ADDENDUM NO. 2

REPLACEMENT OF SEVEN PASSENGER BOARDING BRIDGES

SYRACUSE HANCOCK INTERNATIONAL AIRPORT
SYRACUSE REGIONAL AIRPORT AUTHORITY
SYRACUSE, NEW YORK

IFB REFERENCE #2022-1 & # 2022-2

CA-002

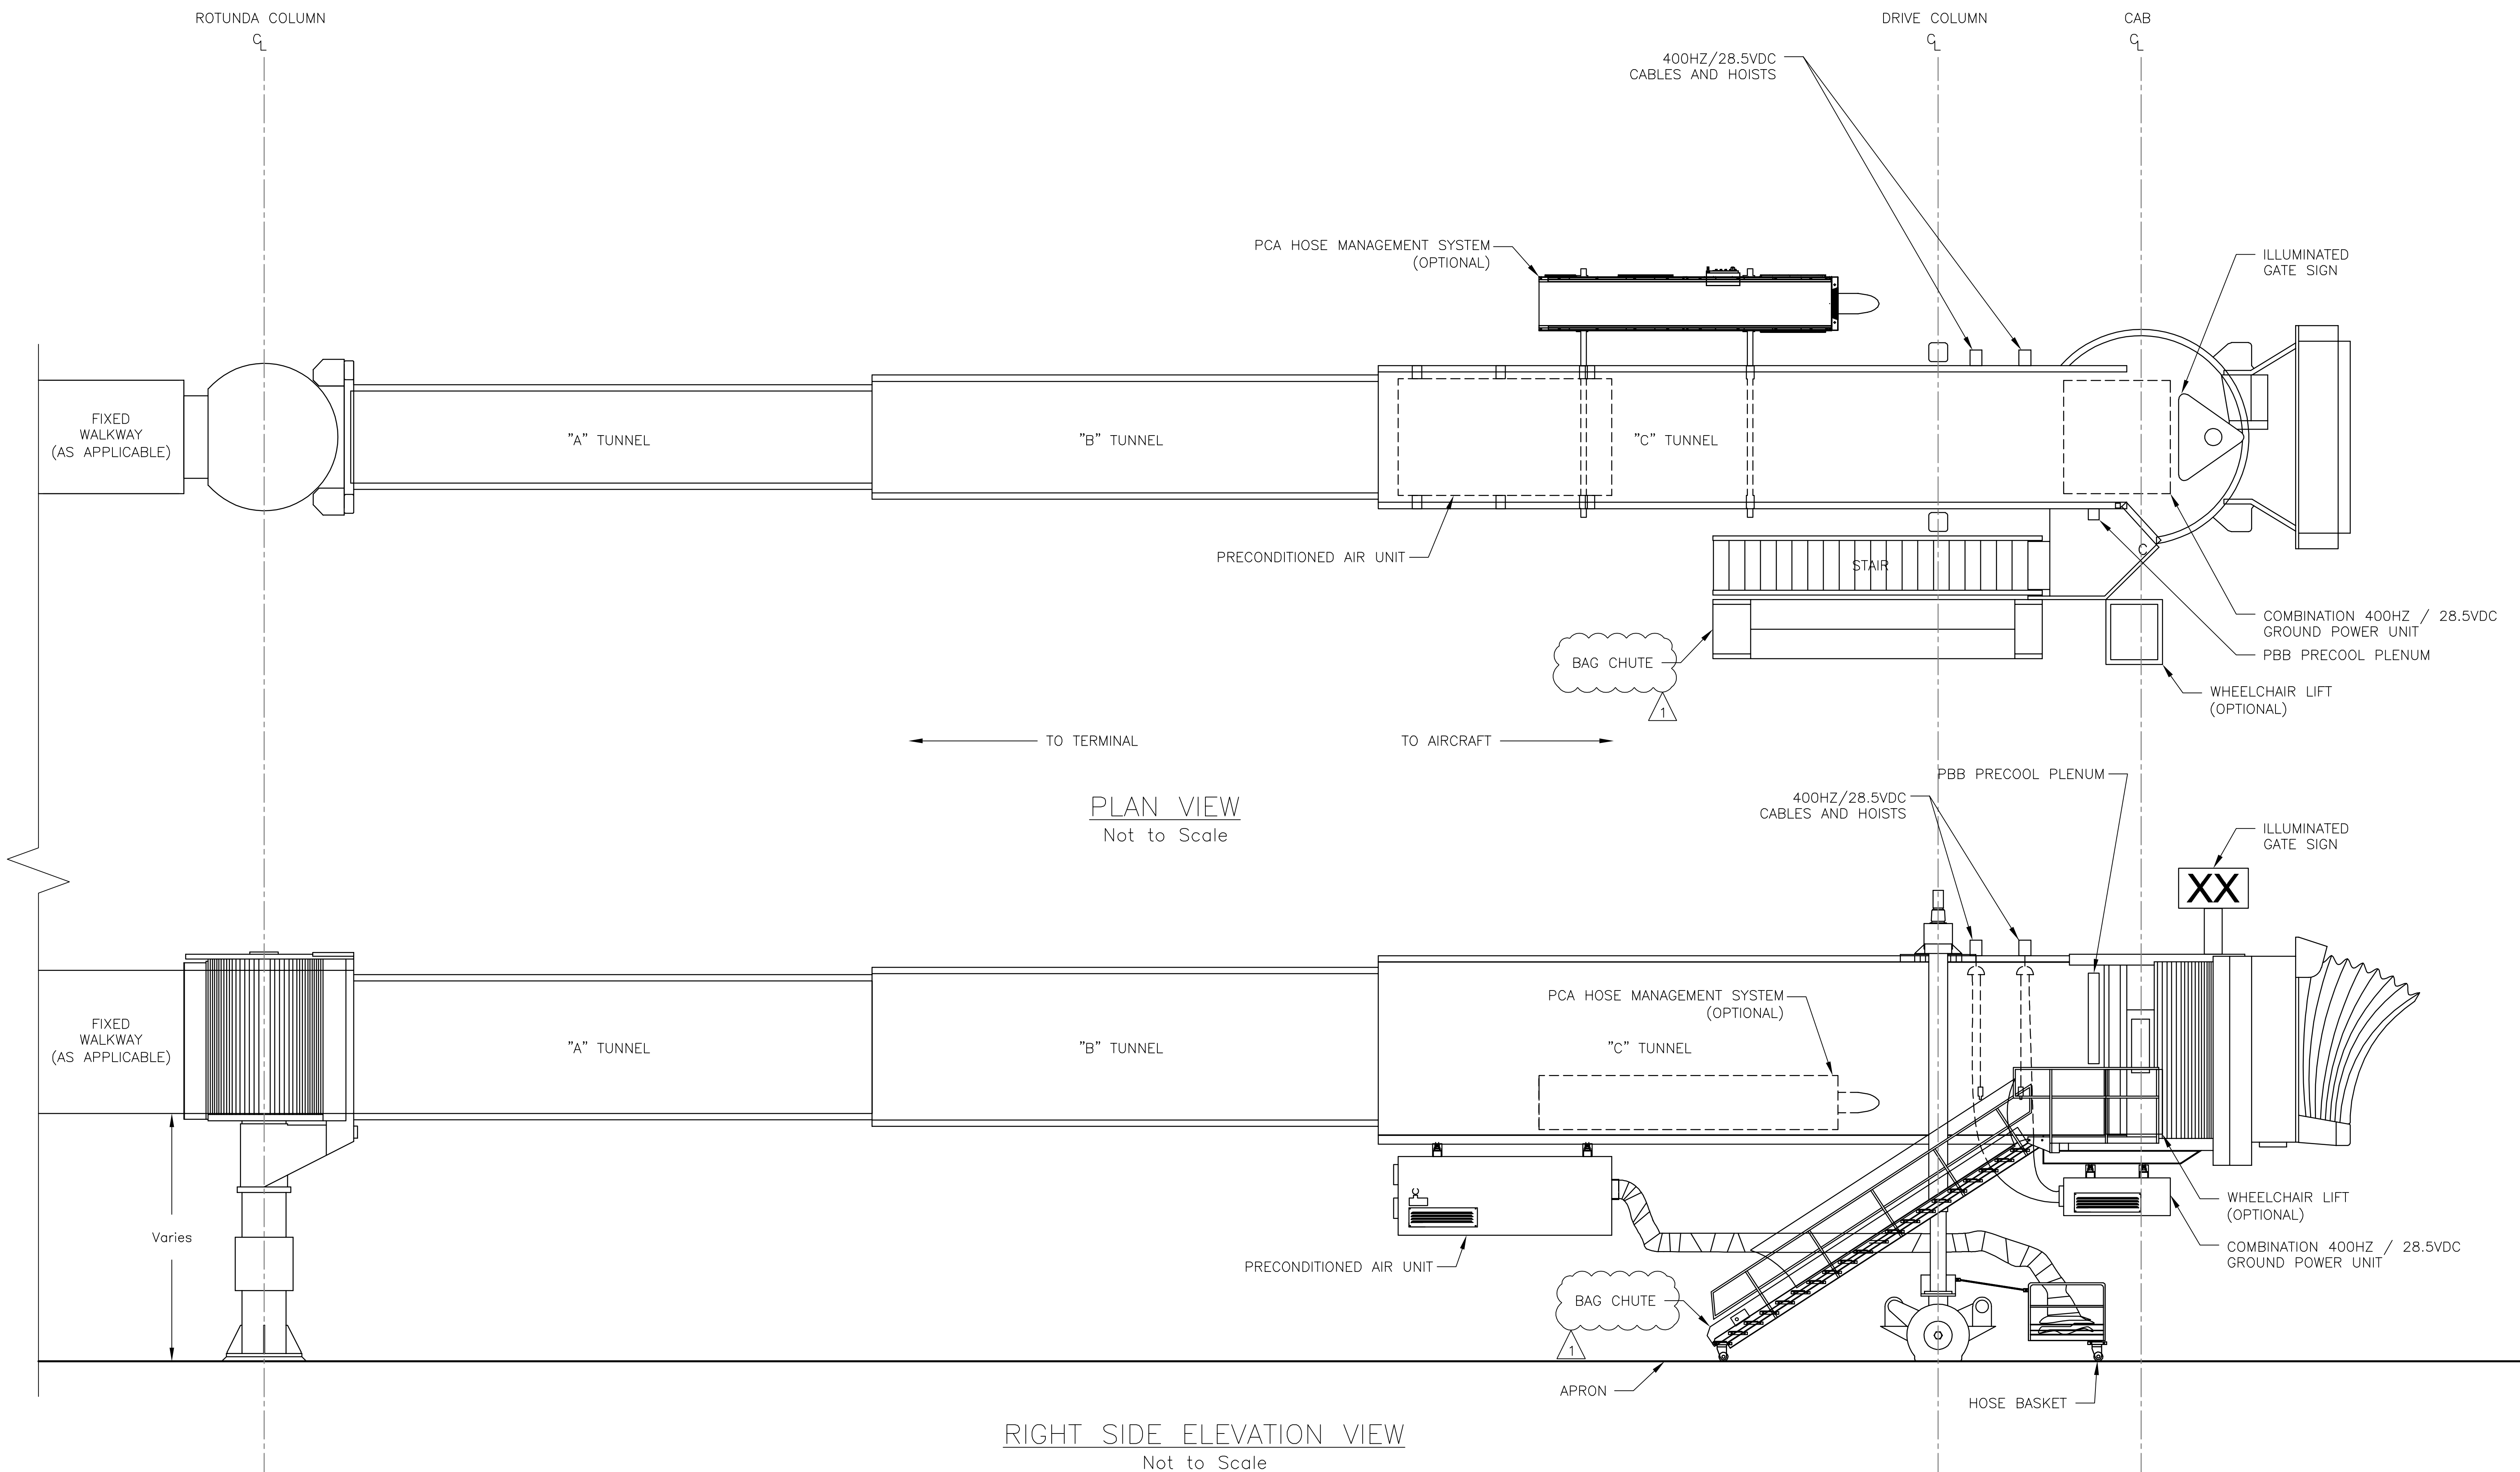
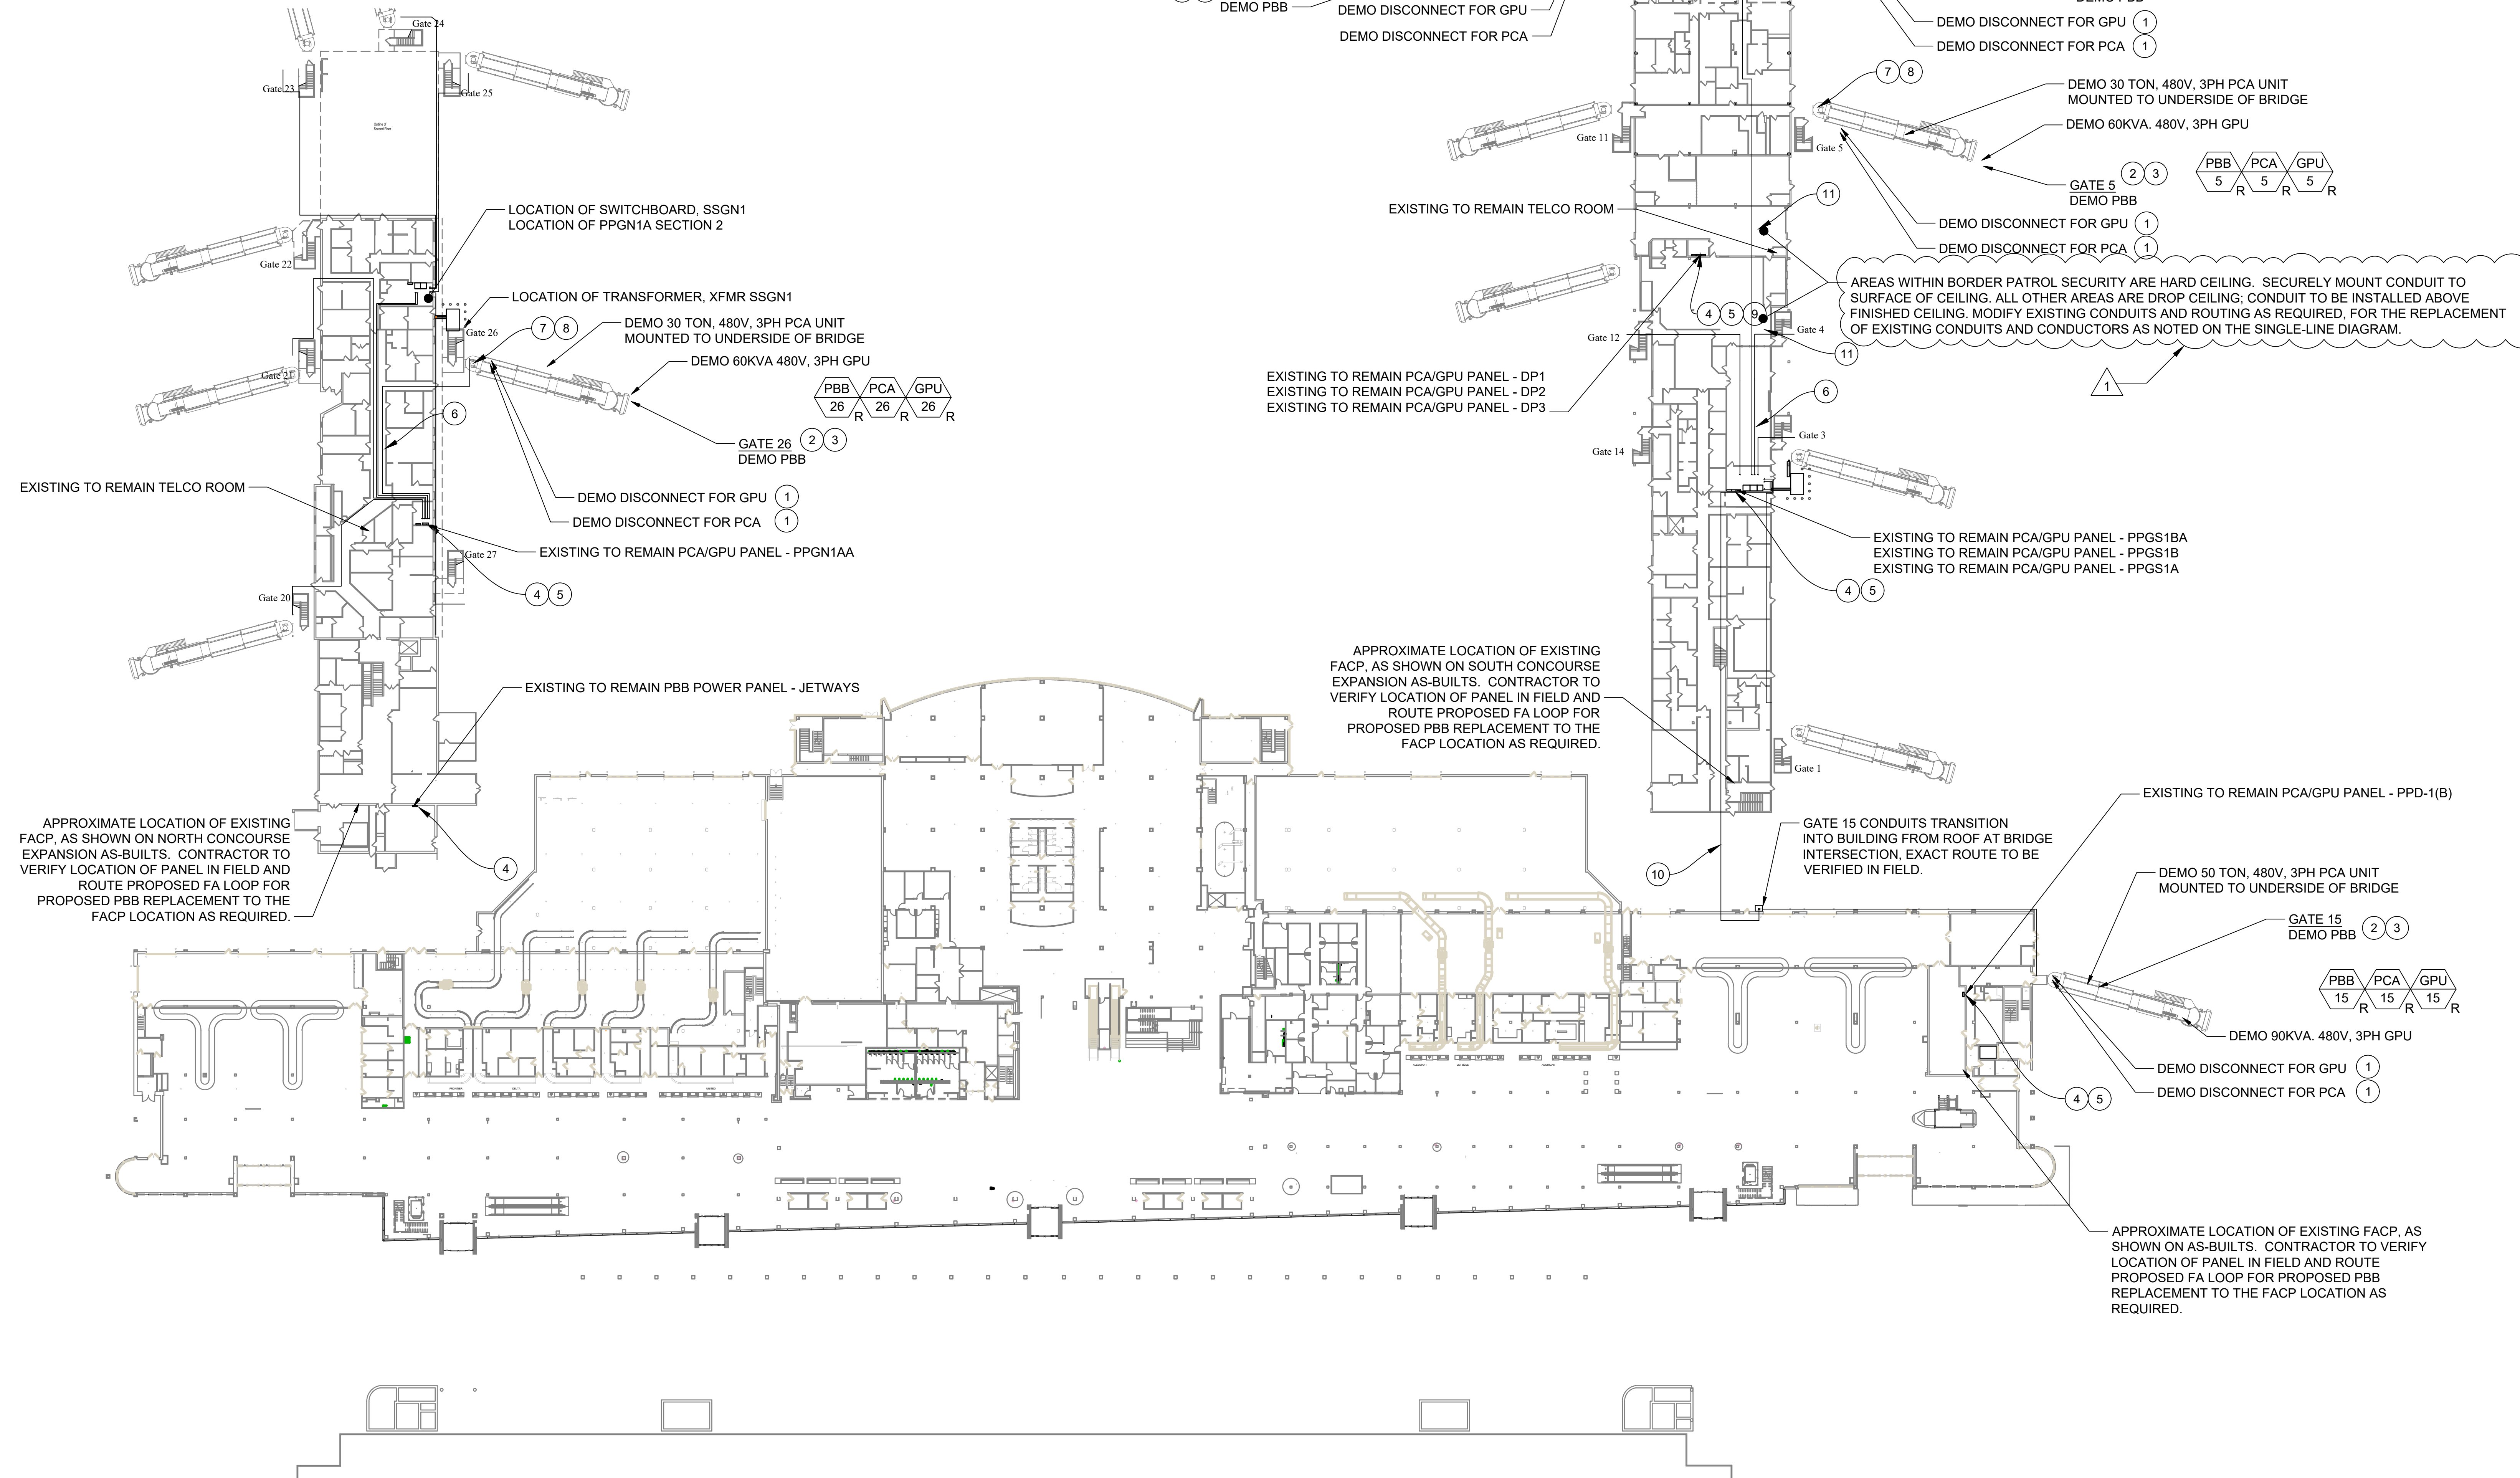
1. **CA-002 – Passenger Boarding Bridge Equipment Details**
 - a) Clarified General Notes
 - b) Changed Baggage Conveyor to Bag Slide
2. **ED-101 – First Floor Electrical Demolition Plan**
 - a) Clarified call-out for work in Border Patrol Security area
3. **E-101 – First Floor Electrical Power Plan**
 - b) Clarified call-out for work in Border Patrol Security area
4. **E-602 – PBB Electrical Connection Details**
 - a) Clarified call-outs for PBB, PCA and 400 Hz feeders
 - b) Added Keyed Note 1 to clarify electrical requirements

5	1/21/2022	SHEET CA-002, Note 2 States, "PBB Equipment and Installation to be provided by Others." Please clarify intent of this statement which specific PBB Equipment and Installation is by others, and which is by this Contract.	1/27/2022	The PBB and all associated equipment indicated on Dwg. No. CA-002 is to be furnished and installed under the General Construction contract. An addendum will be issued to clarify this requirement.

Item	Date	QUESTIONS	Date	RESPONSE
6	1/21/2022	Please confirm each gate is to receive a new Baggage Conveyor system and that none of the gates are to receive a Baggage Slide.	1/27/2022	A baggage conveyor is not required. A bag chute is to be provided. An addendum will be issued to clarify this requirement.
7	1/21/2022	Sheet S-001 requires PBB Contractor to complete physical testing of the existing anchor bolts and foundations. Please confirm this is a requirement as indicated on S-001 notes. Please also confirm, once we complete testing, if it is determined for new PBB load requirements, code changes or existing conditions test results if the existing foundation is not adequate, how will the foundation work be handled? We can complete new foundation design/installation or will that be handled by another Contract. Can you please provide as-built information of the existing foundations.	1/27/2022	Provide pull tests of existing anchor bolts as indicated on Drawing No. S-001. In the unlikely event foundation improvements are needed, a potential change order will be issued to the General Contractor. Drawing Nos. REF-1 through REF-4 contain the available as-built foundation information. There are no as-builts for the Gate 6 foundation. Reliance on any information shown in the Reference Drawings shall be at the bidder's own risk.
